Determination 2016/063

Regarding the compliance of a single inner handrail to a spiral stairway at 158B Lower Flowers Road, Whangamoia, Rai Valley

Summary

Figure 1: Plan of the spiral stair as proposed (not to scale)

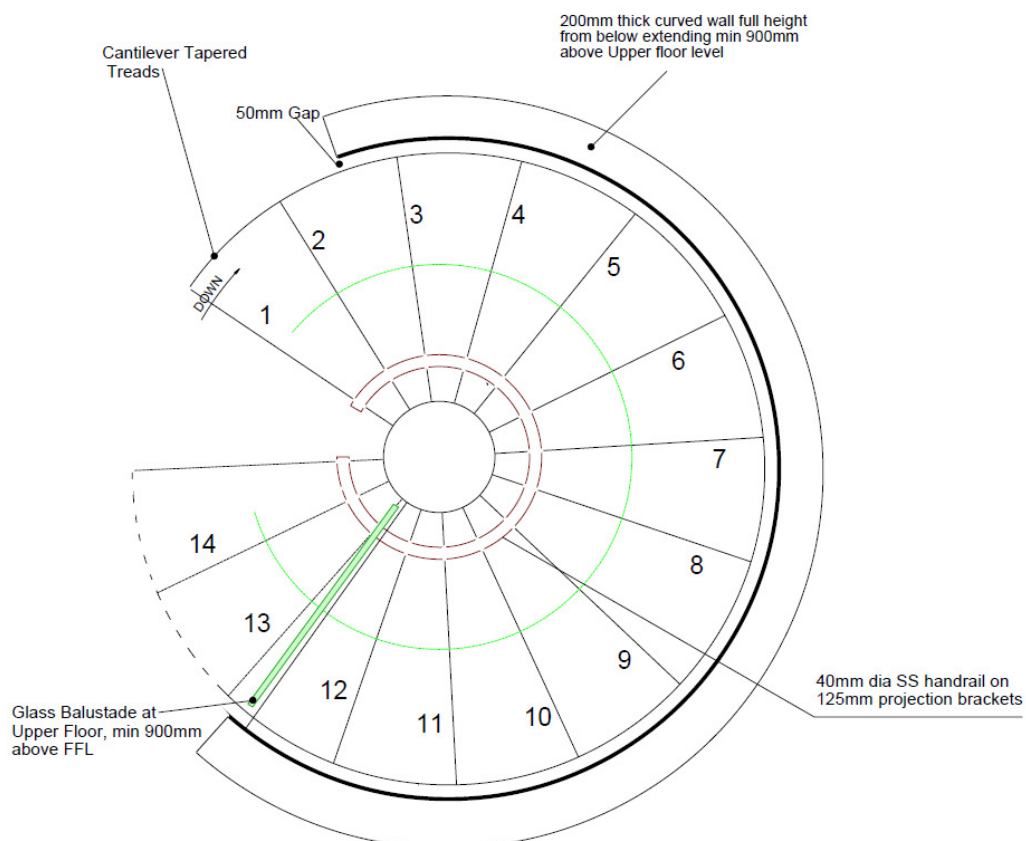
- 2.5 The applicants propose to use a single 40mm diameter handrail located on the inner central column of the spiral stairway on brackets that project away from the column by 125 to 150mm. The applicants advise that the handrail will project past the top riser and will run horizontally for a short distance to provide a ‘lead in’ to the stairs. The rail to the inner column is to proposed to replace that shown on the consented drawings located at the outside edge of the stair.

- 4.4 The authority submitted (in summary):
- It would be impossible for the handrail to be at the same slope as the pitch line as the handrail would effectively be at such a steep slope that it may not arrest a fall.

- When considering compliance with D1/AS1, paragraph 6.0.4, the pitch line of the stair would need to be considered as being hard up against the central column and the handrail would far exceed the pitch line slope requirements of the Acceptable Solution.

- 6.1 In accordance with section 188 of the Building Act 2004, I hereby determine that the proposed handrail to the inner face of the spiral stairs in this case does not comply with Clause D1.3.3(j) of the Building Code.

Figure 2: Angle of consented handrail, proposed handrail, and corresponding pitch line

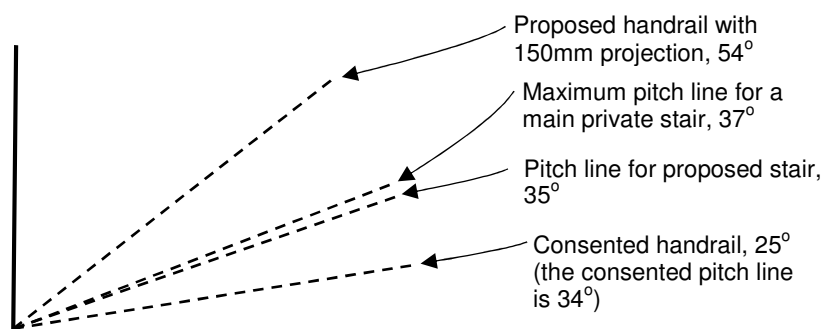
5.2.5 With a 150mm projection off the central column to the spiral stair, the inner handrail will have a slope of 54° (see Figure 2). The slope of the consented handrail to the outer edge of the stair is 25°.

5.2.8 I note here that handrails on either side of a spiral stair will never be at the same slope as the pitch line; the slope of a handrail on the outer face will be shallower, and the slope of a handrail on the inner face will be steeper. The difference will be more pronounced for handrails to the inside of the stair (here 17° steeper) than the outside (9° shallower). The difference disadvantages the user in that the steeper inner handrail is more difficult to grip when descending.

- 5.2.9 The inner handrail, being steeper by 17° than the pitch line, is a significant departure from the Acceptable Solution. The maximum pitch line for this category of stair in the Acceptable Solution is 37° degrees which the spiral stair satisfies – it is noted that the stair satisfies other attributes such as, tread, going, and riser height. However, a usable handrail is an integral component of any stair to assist in ensuring its safe use. While the proposed handrail is of itself the graspable, the angle of the handrail (54°) and the high relative angle of the handrail to the pitch of the stair (17°) in my view means the handrail is not ‘graspable to provide support and assist with movement’.

- 5.3.1 The proposed inner handrail is a significant departure from the solutions described in D1/AS1. In my view the angle of the proposed handrail and the high relative angle of the handrail to the pitch of the stair means the handrail does not satisfy the requirements of Clause D1.

Figure 17: Curved Stairway with Tapered Treads
Paragraphs 4.4.1 a) and b) and 4.5.2

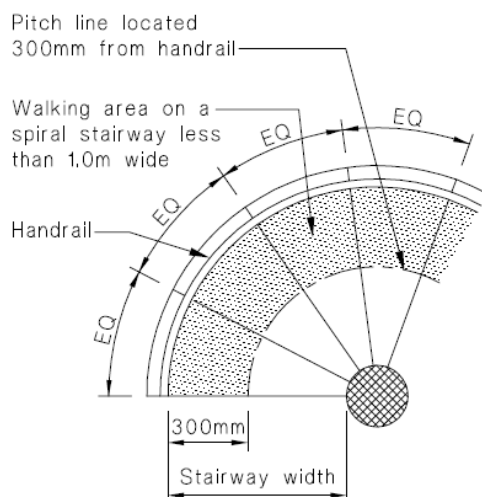
- 5.1.4 Figure 17(a) of D1/AS describes the location of the pitch line, handrail, and the walking area for spiral stairways of widths less than 1000mm. The handrail in figure 17(a) is shown on the outer edge of the spiral stairway.

5.2.3 Paragraph 4.4.1(a) of D1/AS1 sets of the location of the pitch line for spiral stairways with widths less than 1000mm (see Figure 17, Appendix A). Figure 17 shows the handrail to the outer face of the stair with the pitch line 300mm inside the handrail.

5.2.4 The pitch line of the spiral stairs is stated in the plans as 34°. However, the plans show this 300mm from a handrail located at the outer edge of the stair. If the handrail is to be located on the inner face, as is proposed, then the pitch line for the stair is measured 300mm from the proposed handrail – the pitch line as proposed would therefore be 35°. Irrespective of this, I consider there is a natural tendency to use spiral stairs where the tread is most comfortable to the user: this is at or towards the outside of the stair, not the inside.

Figure 18: Stair Winders
Paragraphs 4.5.1 and 4.5.2

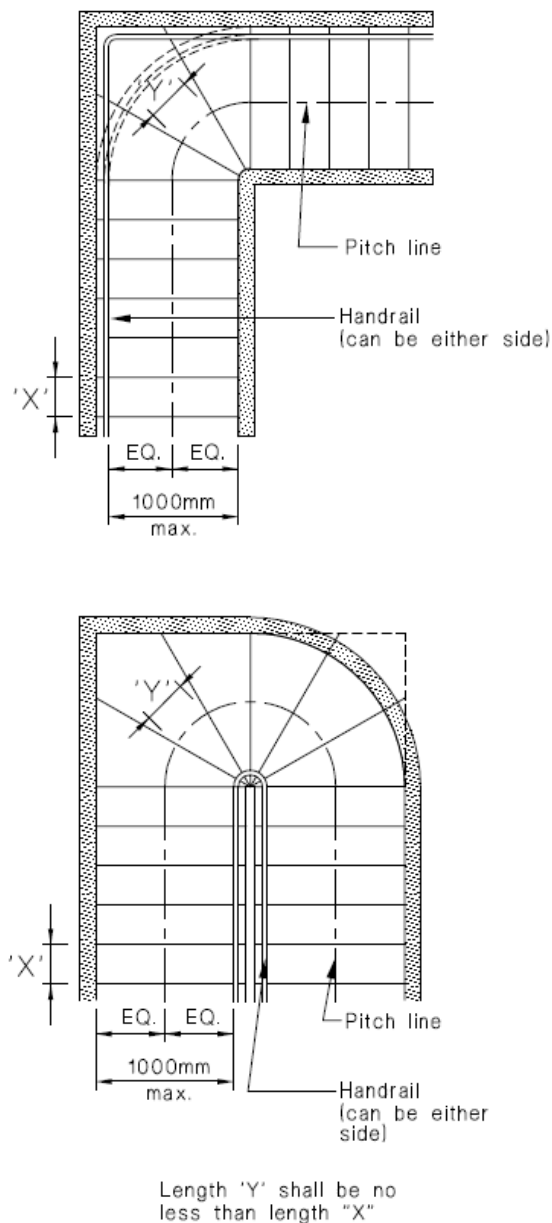
- Figures 18 in D1/AS1 states that a tapered tread (winder), less than 1m width, rotating through 90 and 180 degrees may have handrails positioned on either side. This demonstrates the acceptability of handrails on the inside radius of a stair.

- Figure 18 of D1/AS1 refers to winders, not handrails; the spiral stair does not conform to the features in paragraphs under 4.5 of D1/AS1 relating to winders.

- 5.1.3 The applicants' submission is, in part, correct. Figure 18 does state that handrails can be on 'either side' of the stair. However, Figure 18 references winders with adjoining straight flights of stairs (refer paragraph 4.5 of D1/AS1). The stairway in this determination is a spiral stairway and therefore, in my opinion, Figure 18 is not applicable and cannot be read as providing for a single handrail to a spiral stair. A spiral stairway is a 'stair describing a helix around a central column'. A spiral stair does not contain a straight flight of steps as shown in Figure 18.

Figure 3. Measurement of clear width and goings

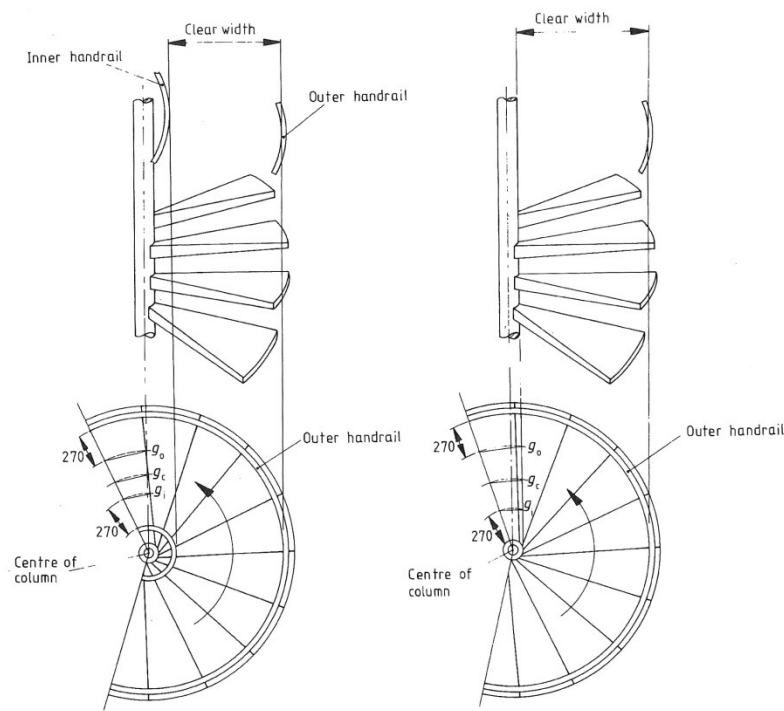
- Figure 3 of BS 5395: Part 2: 1984 shows two examples of spiral stairs. The example including an inner rail also has handrail on the outside; the example with one rail shows it on the outside. This suggests that the inner handrail can only be used in conjunction with an outer handrail.
